Access Compliance Report

Public Rights-of-Way

(Curb Ramps)

Intersection ID: 10033236	Main Street: OAK_LAKE_BV	Cross Street: N/A	Location: E
ADA ID: 13E6552E926A	Ramp Type: PerpDiag	Initial Pass/Fail: Fail	Overall Compliance: No
		Severity Score: 8.75

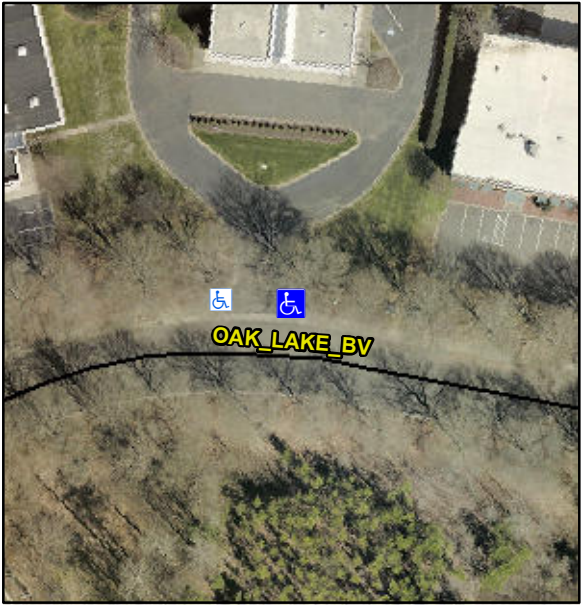
Codes/Mitigation Info/Possible Solution			Field Measurements/Component Compliance			
	Possible Solutions:		Compliance	Description	Data	
	Remove & Replace Curb Ramp With Two New Directional Ramps or Equivalent.		N/A	Ramp Length (in)	36.0	Yes
			No	Ramp Width (in)	46.0	Yes
			N/A	Flare Type LT	N/A	N/A
			N/A	Flare Slope LT (%)	N/A	N/A
			N/A	Flare Traversable LT?	N/A	N/A
			N/A	Landing Length (in)	N/A	N/A
			N/A	Landing Width (in)	N/A	N/A
			N/A	Landing Slope (%)	N/A	N/A
			N/A	Landing X Slope (%)	N/A	N/A
			N/A	Landing Curb? (Y/N)	N/A	N/A
			N/A	Shared Landing?	N/A	
			N/A	Gutter Ponding?	N/A	N/A
			N/A	Gutter Lip Ht (in)	N/A	N/A
			N/A	Painted X Walk1?	No	N/A
				X Walk 1 Direction	To W	
			N/A	X Walk 1 Width (in)	N/A	N/A
				X Walk 1 Slope (%)	1.3	
				X Walk 1 X Slope (%)	1.0	
			N/A	Ramp inside XWalk1?	N/A	N/A
<p>Surveyor Notes:</p> <p>N/A</p> <p>PROW/ADA:</p> <p>Not Found, R304.5.1</p>				Ramp Slope (%)	5.3

Ramp XSlope (%)	1.4	
				Flare Type RT	N/A	
				Flare Slope RT (%)	N/A	
				Flare Traversable RT?	N/A	
				DWS Provided?	N/A	
				DWS Contrast?	N/A	
				DWS Length (in)	N/A	
				DWS Full Width?	N/A	
				DWS Offset (in)	N/A	
				Gutter Slope (%)	N/A	
				Gutter X Slope (%)	N/A	
				Painted X Walk2?	No	
				X Walk 2 Direction	To S	
				X Walk 2 Width (in)	N/A	
				X Walk 2 Slope (%)	1.6	
				X Walk 2 X Slope (%)	2.1	
				Ramp inside XWalk2?	N/A	
				Clear Space?	N/A	
				Clear Space to XWalk (in)	N/A	
<p>Total Cost:</p> <p>\$ 3200.00</p>				Storm Grate/Utility Hazard?	N/A	
				Storm Grate/Utility Type		
					N/A	N/A
				Surface Condition? (G/P)	Good
